3 Detailed description of change

Product Change Notification					PCN 5707 Thread improvement		
owner	creation date	release date	released by	change order	rev	page	D10-102-892
seilerra	13.08.2026	28.08.2026	blumhe		A	1 of 2

PCN 5707 Power Entry Modules with Filter**List of part numbers affected**

Current product appearance	New product appearance

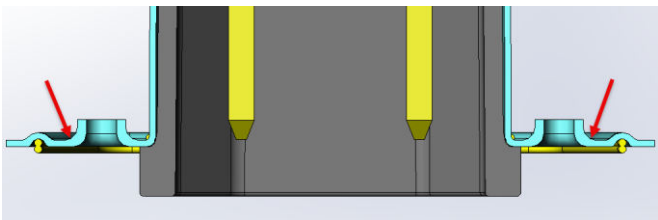
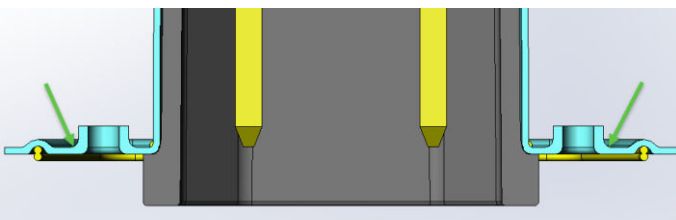
- Changing the radius to achieve more thread turns
- Height of thread remains unchanged
